MEMO

TO: Tim Rhode, Village Administrator
 FROM: Ryan Amtmann, Village Engineer
 DATE: July 8, 2020
 SUBJECT: Willow Drive Connection

This memo provides information to support the discussion regarding the connection of Willow Drive to a public road being proposed in the LCL development area.

Typical Village Residential Urban Section

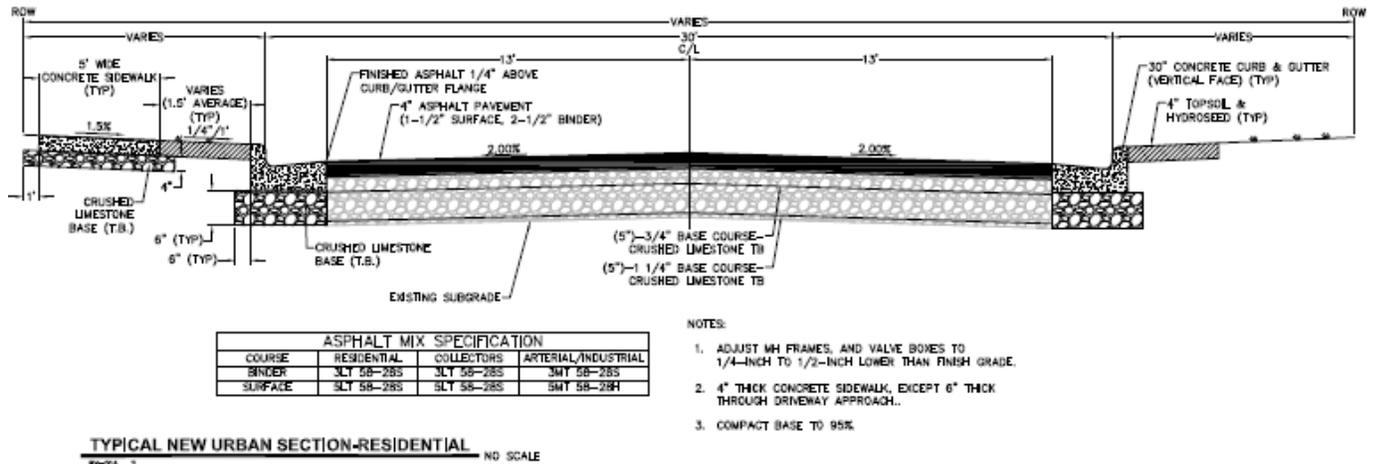
- 30-foot wide face of curb to face of curb
- Typically used for lower volume residential roadways
- Assume 8-ft wide for parking, 10.5-ft wide for drive lanes.
 - Allows for parking on 1 side of street or staggered parking on both sides of streets
 - Parking on both sides of street in same location creates a bottleneck with only 14-foot of room between parked cars, tight to not enough room for cars to pass one another
 - Could consider signing the roadway as parking on one side only
- Other roadways in the Village that are 30-foot wide curb to curb include:
 - Sunnyslope Drive (Rae to Merton) – the eastern 1/2 of Sunnyslope is signed for parking on 1 side of the road only
 - Renson Road (Nixon to Merton)

Typical Collector Urban Section

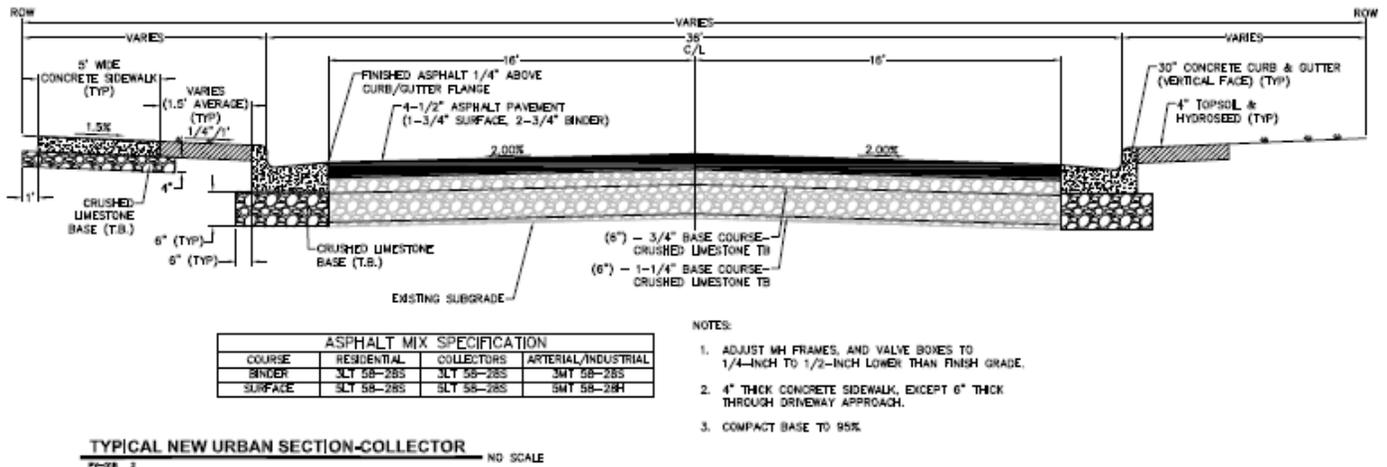
- 36-foot wide face of curb to face of curb
- Typically used in areas with more through traffic and higher volumes
- Assume 8-ft wide for parking, 10-ft wide for drive lanes.
 - Allows for parking on 2 sides of street with 20-foot of room between cars
- Other roadways in the Village that are 36-foot wide curb to curb include:
 - Oxford Drive
 - Imperial Drive
